MARK	DATE	DESCRIPTIONS	BY	CH'D	CCO#
		REVISIONS			
6	03/07/14	INSTALL CALL BOXES	RG	AM	341S1
5	09/27/13	CALL BOXES	RM	AM	341
4	05/10/10	WEST END BARRIER CONDUIT	NK	MSO	44S1
3	08/03/09	ELECTRICAL WARNING SYSTEMS	GB	MSO	61
2	03/30/09	SERVICE PLATFORM ELECTRICAL CHANGES	NK	MSO	55
1	03/04/08	BARRIER MODIFICATIONS	EL	MI	44

CONTRACT CHANGE ORDER NO. 341 S1
SHEET 2 OF 14

BRIDGE NO. 34-0006
KILOMETER POST 13.2/13.9

SAS SUPERSTRUCTURE
ELECTRICAL PANEL SUPPORT SECTIONS
AS-13

SAS SUPERSTRUCTURE ROADWAY WESTBOUND
LIGHTING AND ELECTRICAL SYSTEMS
SCALE 1:200

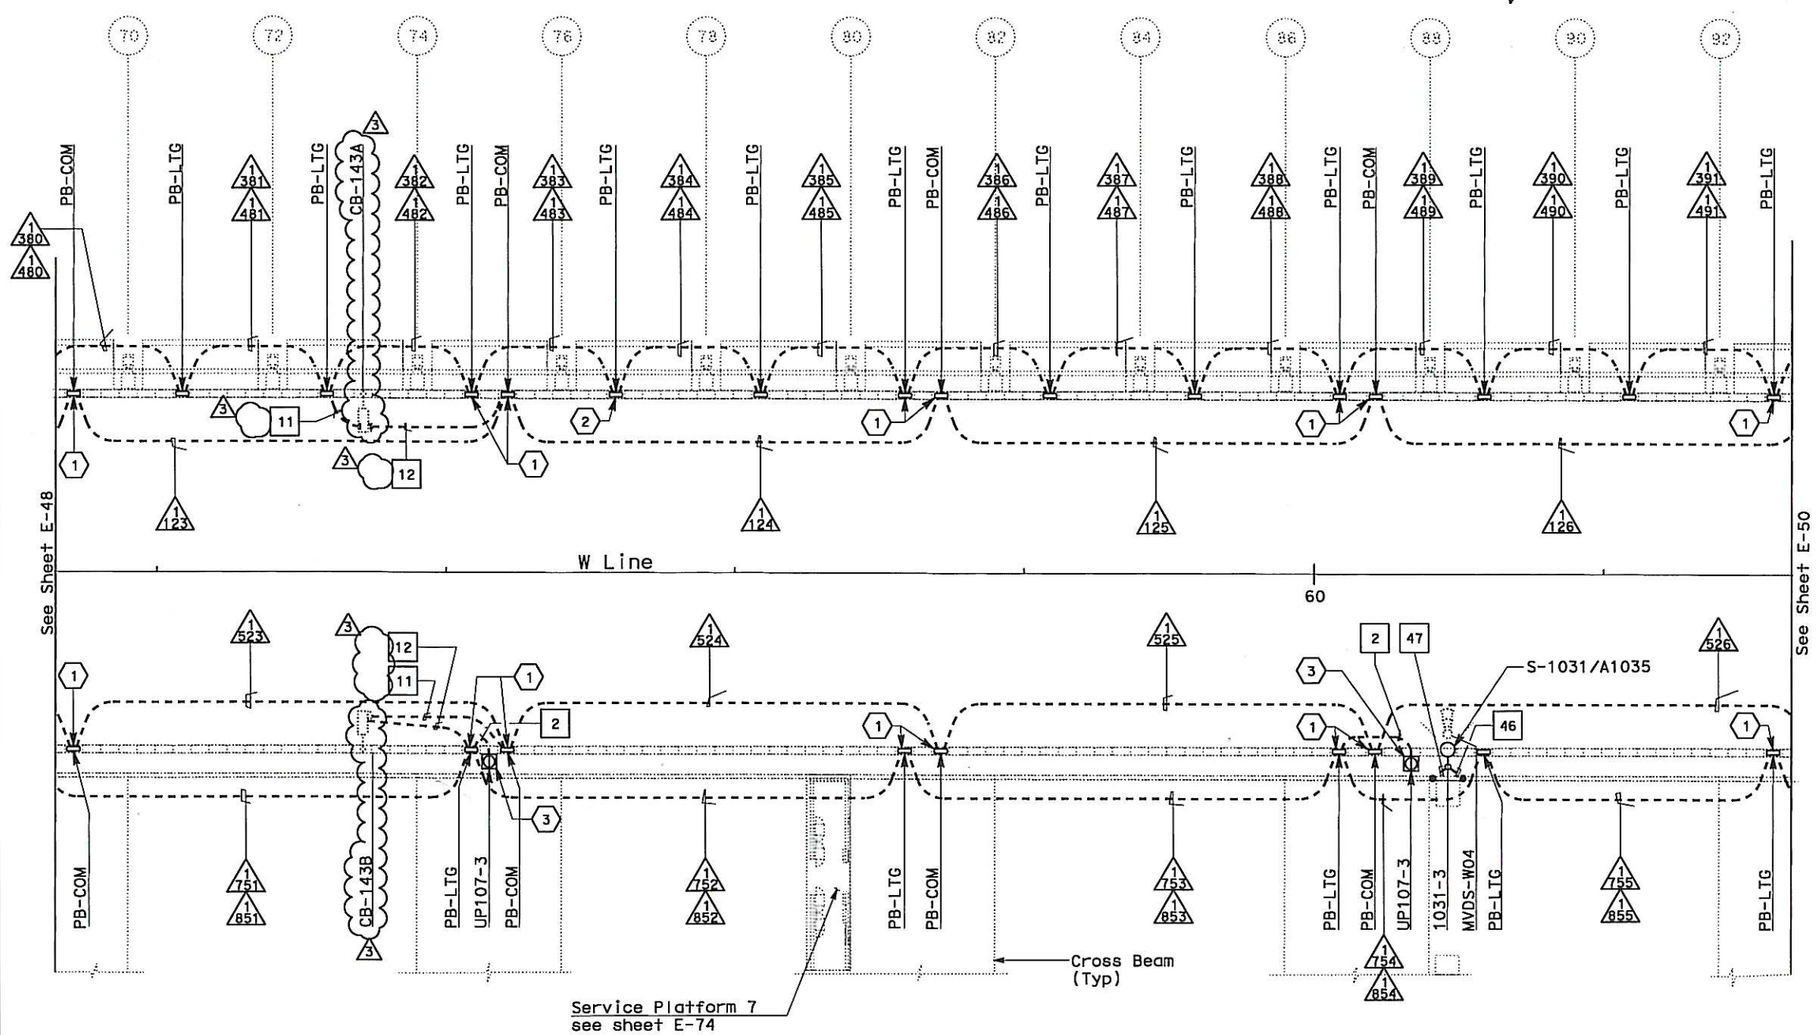
MARK	DATE	DESCRIPTIONS	BY	CH'D	CCO#
3	03/07/14	INSTALL CALL BOXES	EL	RG	341S1
2	10/01/13	CALL BOXES	RR RSB	RG	341
1	02/19/08	ELECTRICAL MODIFICATIONS	MP EL	RR	42

1. Conduit from barrier pullbox or other equipment down into Girder, See sheet E-99.
2. For conduit to Suspend Lighting, See sheet E-229. Typ for all PB-LTG located on the north side of the roadway.
3. Roadway Barrier Receptacle, see Detail 1, sheet E-68
4. Deleted

DETAILS
SAS SUPERSTRUCTURE ROADWAY WESTBOUND
PANEL UP-108 SCHEDULE
NO SCALE

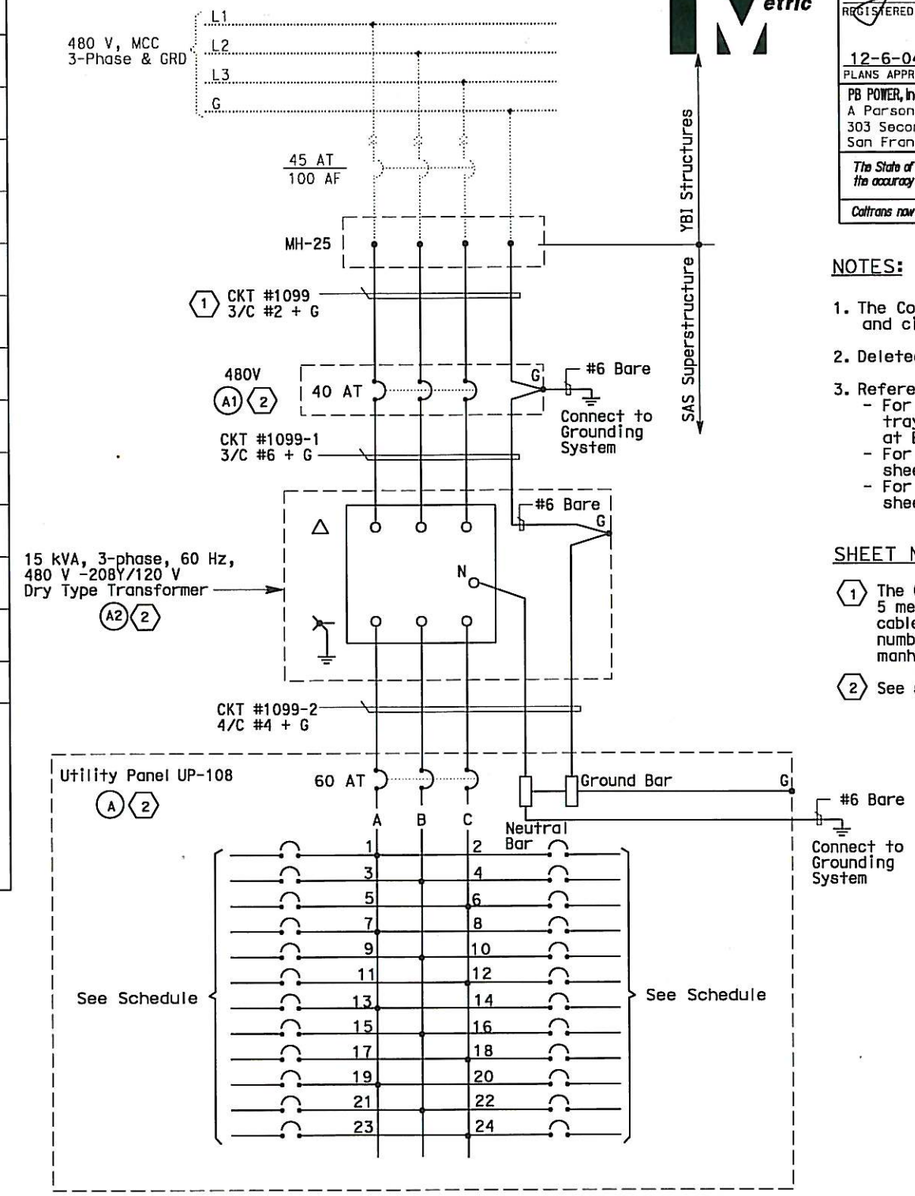
REQUEST FOR INFORMATION NOT ADDRESSED IN THIS CCO REMAIN IN FORCE					
5	03/07/14	INSTALL CALL BOXES	EL	RG	341S1
4	09/27/13	CALL BOXES	RR RSB	RG	341
3	02/08/13	ADDITIONAL SAS/SKYWAY MISCELLANEOUS ELECTRICAL CHANGES	RR RSB	RG	191S1
2	03/30/09	SERVICE PLATFORM ELECTRICAL CHANGES	RR MP	RG FW	55
1	03/04/08	BARRIER MODIFICATIONS	JS BM	RG SE	44
MARK	DATE	DESCRIPTIONS	BY	CH'D	CCO#
		REVISIONS

DETAILS
SAS SUPERSTRUCTURE ROADWAY CONDUIT AND PULL BOX LOCATIONS
SCALE AS NOTED

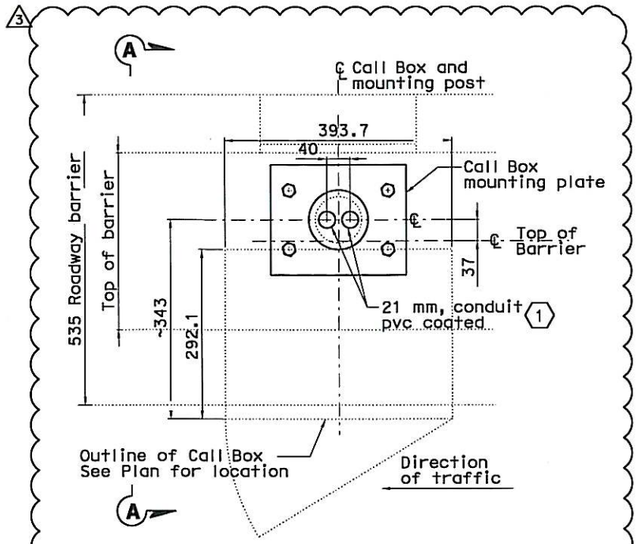
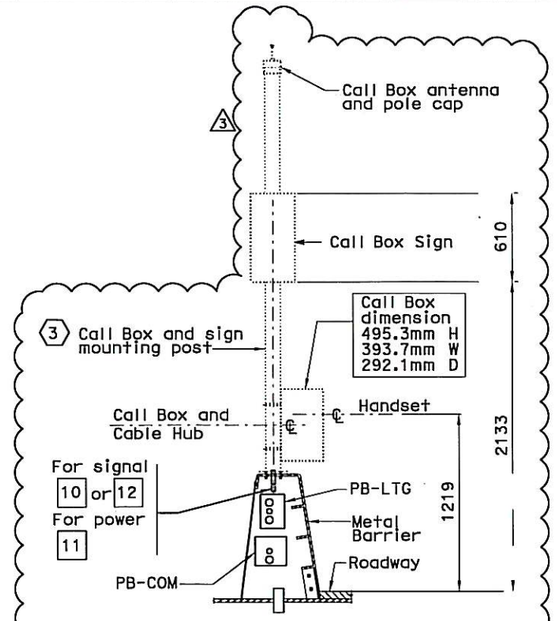
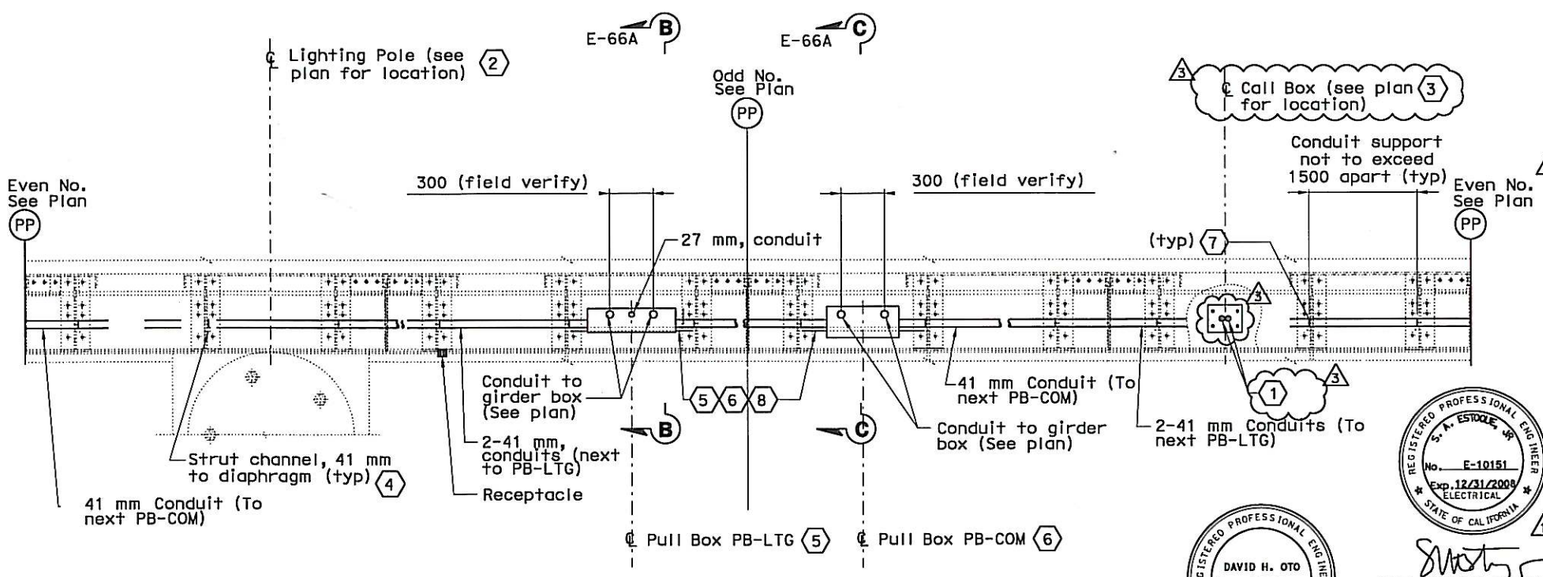
MARK	DATE	DESCRIPTIONS	BY	CH'D	CCO#
3	03/07/14	INSTALL CALL BOXES	EL	RG	341S1
2	10/01/13	CALL BOXES	RR RSB	RG	341
1	03/04/08	BARRIER MODIFICATIONS	JS BM	RG SE	44

1. References:
   - For pull box schedule, see Sheet E-83.
   - For light pole schedule, see Sheet E-82.
   - For call box schedule, see Sheet E-397
2. For location of pull boxes inside girder, see Sheet E-96 through E-101.
3. For mounting hole detail of call box on roadway metal barrier, see sheet AS-13. 3

SAS SUPERSTRUCTURE ROADWAY EASTBOUND
LIGHTING AND ELECTRICAL SYSTEMS

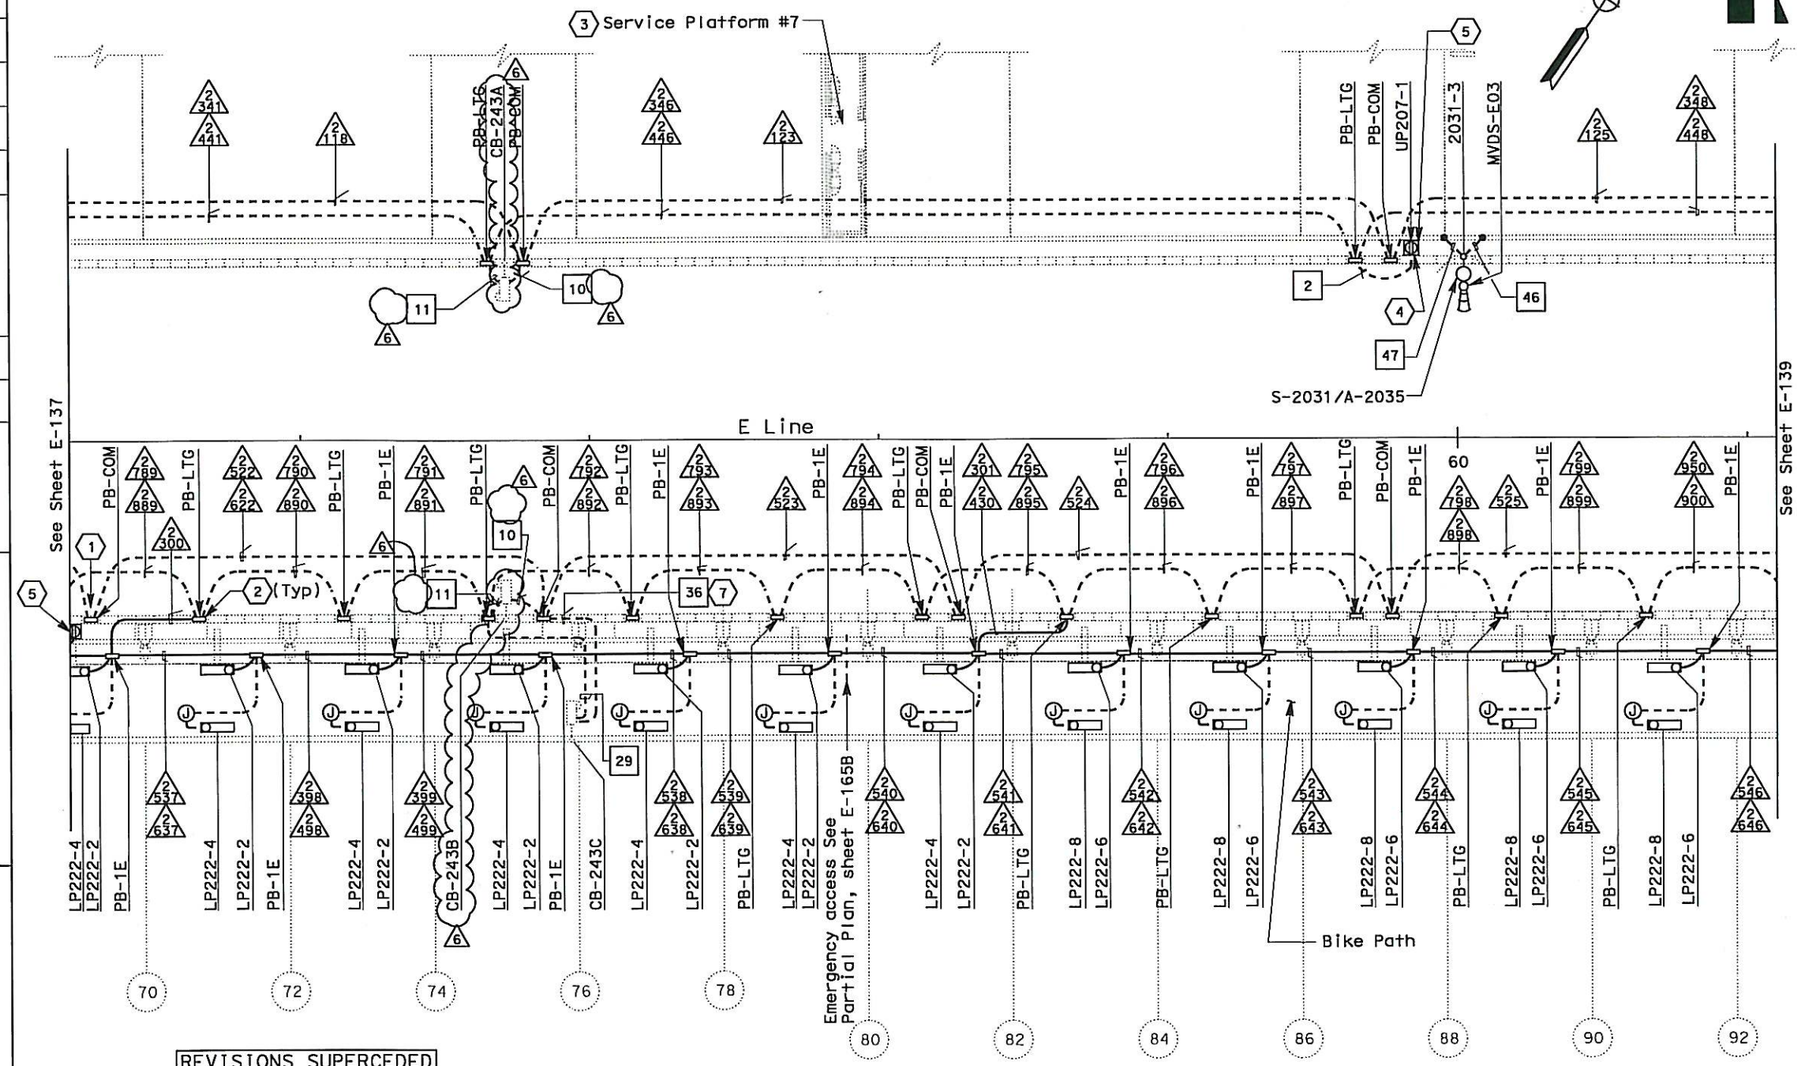
MARK	DATE	DESCRIPTIONS	BY	CH'D	CCO#
6	03/07/14	INSTALL CALL BOXES	EL	RG	341S1
5	10/01/13	CALL BOXES	RR RSB	RG	341
4	04/15/11	BIKE PATH CONDUIT	TW	RG	73
3	06/11/10	BIKE PATH CONDUIT	TW	RG	73
2	12/15/08	BIKE PATH DETAILS	TW	RG FW	99
1	02/19/08	ELECTRICAL MODIFICATIONS	MP EL	RR	42

1. References:
   - For typical details and locations of conduit connections to light poles, barrier outlet boxes, call boxes, overhead sign lighting, CMS, CCTV and MVDS, see sheets E-160 thru E-162 and E-169.
   - TOS equipment is shown for conduit routing only. For typical details of TOS controller and devices, see sheets E-344 through E-357.
   - For types of pull boxes, splice boxes and enclosures, see sheet E-169.
   - For circuit and conduit/cable tray schedules, see sheets starting at E-401.
2. For Roadway Level Call Boxes, refer to sheet E-396.

DETAILS
SAS SUPERSTRUCTURE ROADWAY EASTBOUND PANEL UP-208 SCHEDULE
NO SCALE

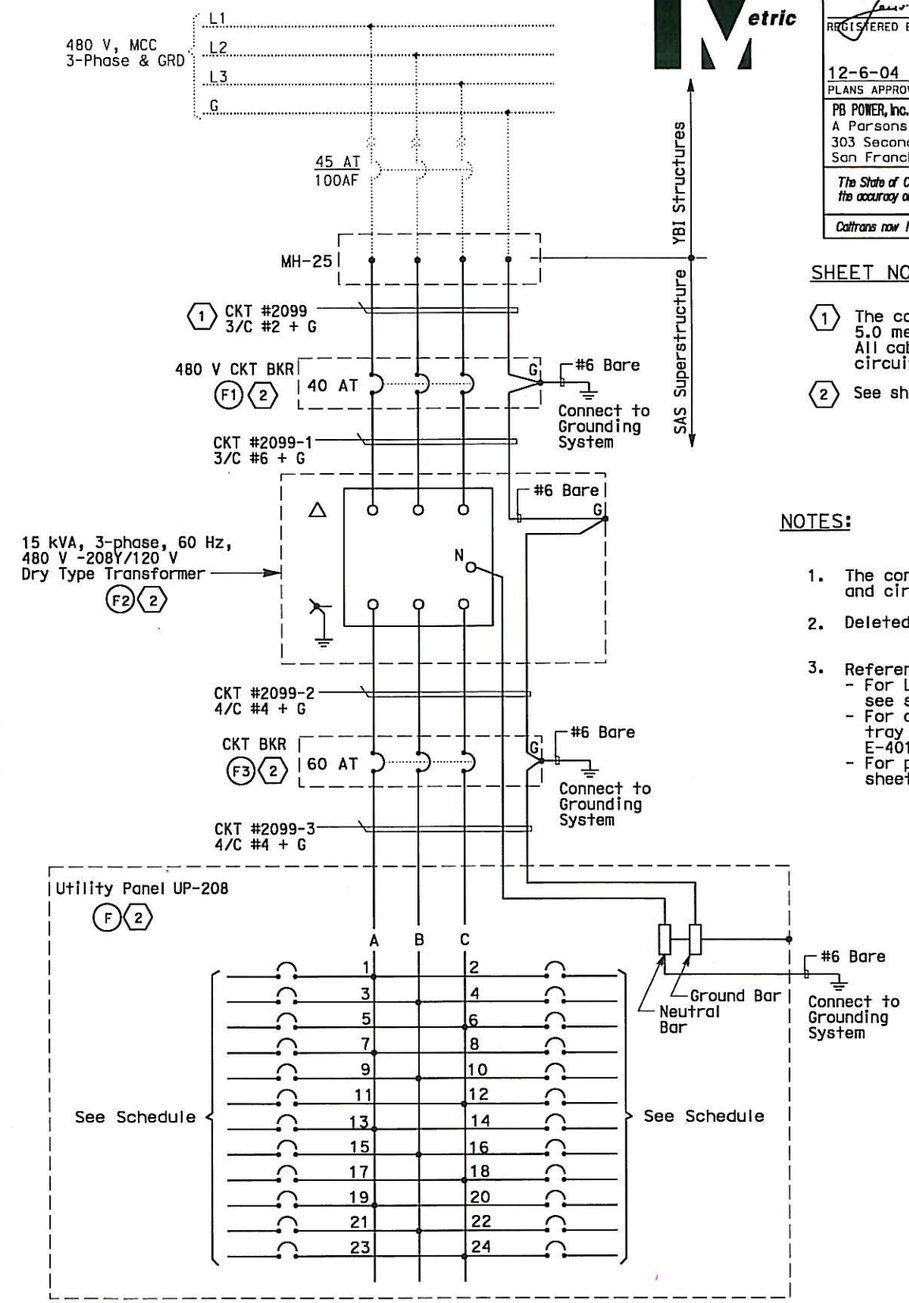
MARK	DATE	DESCRIPTIONS	BY	CH'D	CCO#
(6)	03/07/14	INSTALL CALL BOXES	EL	RG	341S1
(5)	09/27/13	CALL BOXES	RR RSB	RG	341
(4)	02/08/13	ADDITIONAL SAS/SKYWAY MISCELLANEOUS ELECTRICAL CHANGES	RR	RG	191S1
(3)	04/10/09	ELECTRICAL WARNING SYSTEMS	RY RR	RG FW	61
(2)	03/30/09	SERVICE PLATFORM ELECTRICAL CHANGES	RR MP	RG FW	55
(1)	03/04/08	BARRIER MODIFICATIONS	JS BM	RG SE	44

DETAILS
SAS SUPERSTRUCTURE ROADWAY
CONDUIT AND PULL BOX LOCATIONS
SCALE AS NOTED

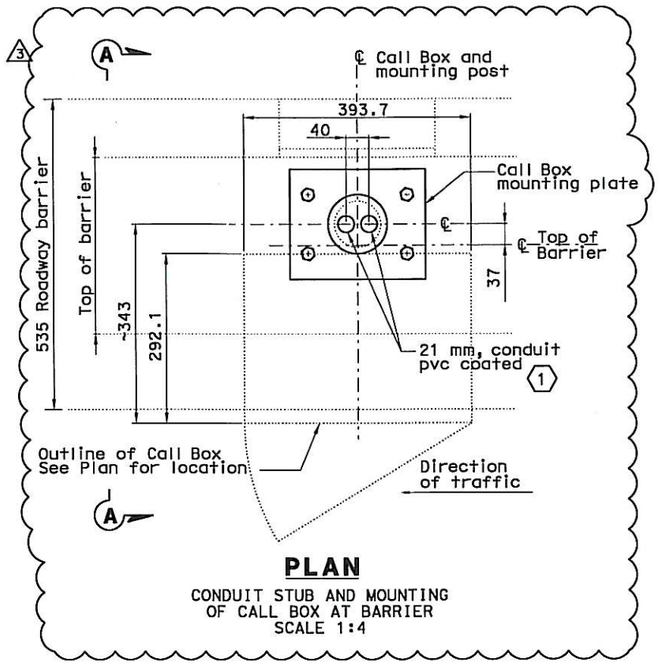
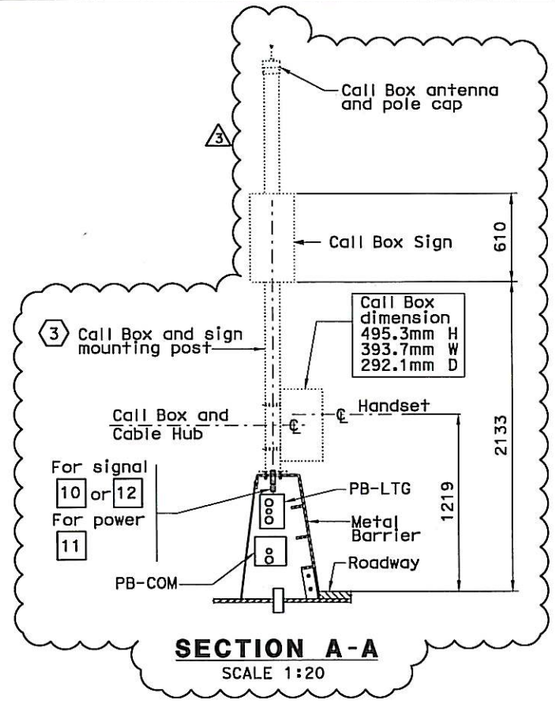
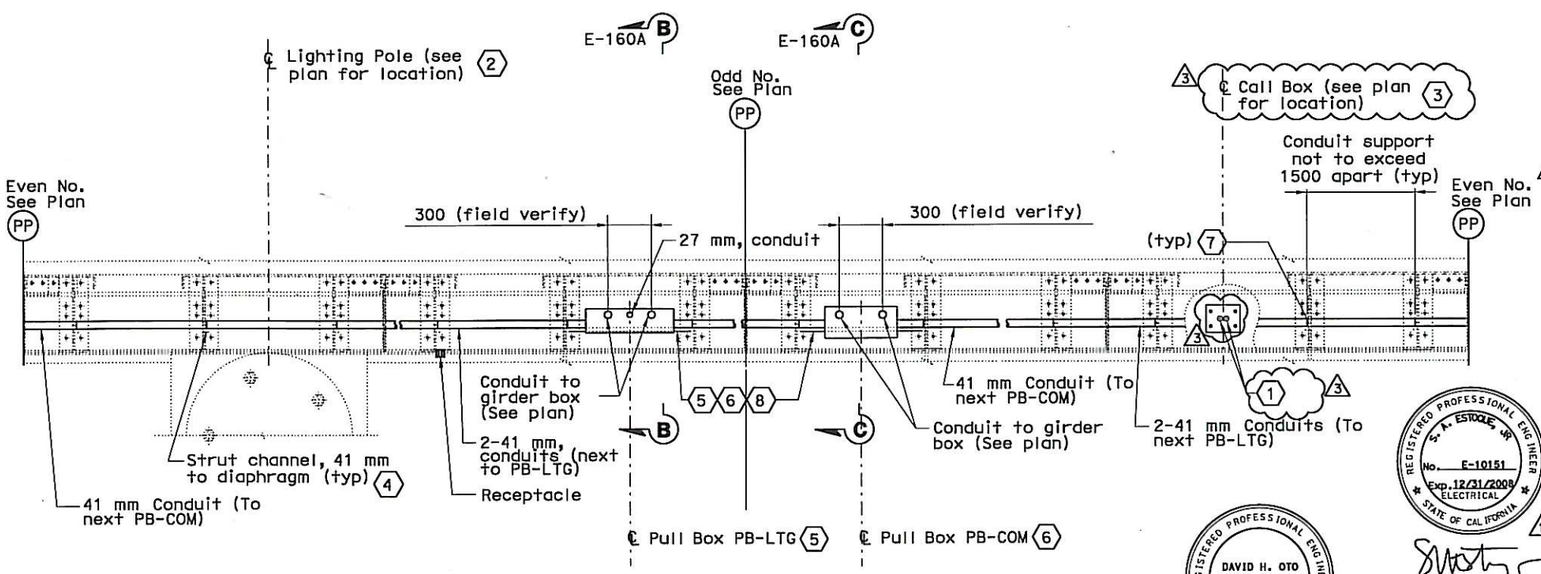
REQUEST FOR INFORMATION NOT ADDRESSED IN THIS CCO REMAIN IN FORCE					
3	03/07/14	INSTALL CALL BOXES	EL	RG	341S1
2	10/01/13	CALL BOXES	RR RSB	RG	341
1	03/04/08	BARRIER MODIFICATIONS	JS BM	RG SE	44
MARK	DATE	DESCRIPTIONS	BY	CH'D	CCO#
		REVISIONS

1. References:
   - For pull box schedule, see Sheet E-169.
   - For light pole schedule, see Sheet E-166.
   - For call box schedule, see Sheet E-397
2. For location of pull boxes inside girder, see Sheet E-35 through E-140.
3. For mounting hole detail for call box on roadway metal barrier, see sheet AS-13. (3)
